**SYDNEY WESTERN CITY PLANNING PANEL
COUNCIL ASSESSMENT REPORT**

| Panel Reference | PPSSWC-64 |
| DA Number | DA-266/2015/A |
| Street Address | 25 Martin Road, Badgerys Creek LOT 1 DP 611519 |

Image 2: Elevations proposed under current modification application DA-266/2015/A

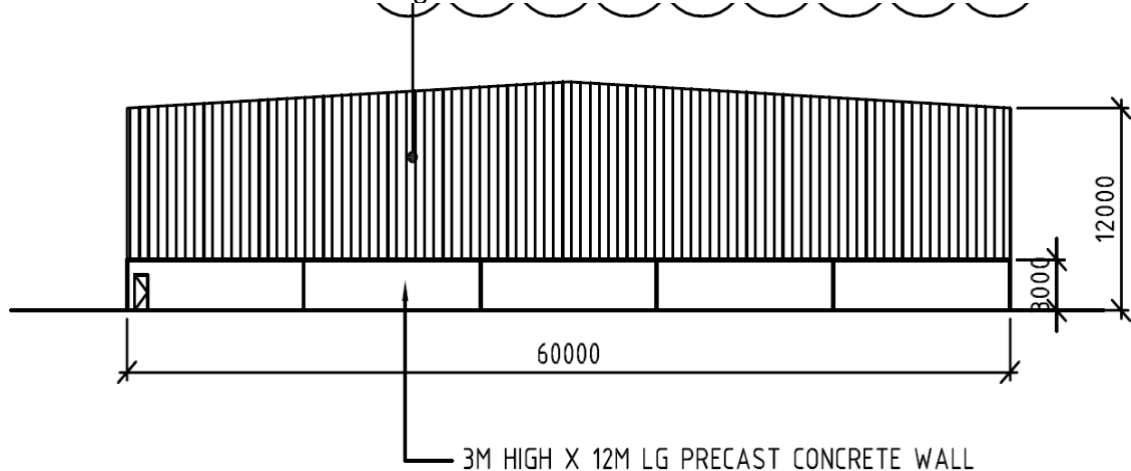
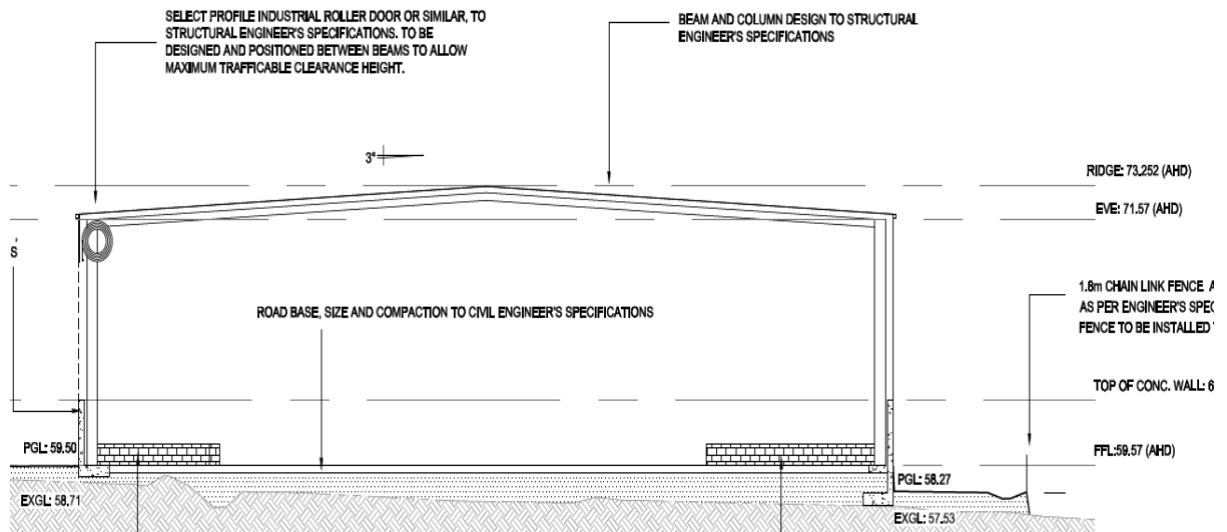
To be noted from the above is the lack of any nominated reduced levels.

As demonstrated in Image 2 above, the current modification application provides proposed finished levels resulting in the following:

- Maximum eave height 15.49 metres (south western corner of the building)
- Maximum roof ridge height 16.752 metres on the western facade
- Maximum cut to achieve FFL 1.59mm (NE corner of building)
- Maximum fill to achieve FFL 3.03 metres (SW corner of building)

As the current modification does not propose an increase in wall height or ridge height, and the finished floor and roof RLs were not specified for the DA, the proposal currently before Council is substantially the same development, both quantitatively and qualitatively, and does not propose a radical transformation from the original approved proposal.

The cut and fill plan provided in support of this addendum identifies that the grading of the site to create a level construction surface will not require the export of fill from the site. On this basis, the proposal is considered to be substantially the same development as originally approved.
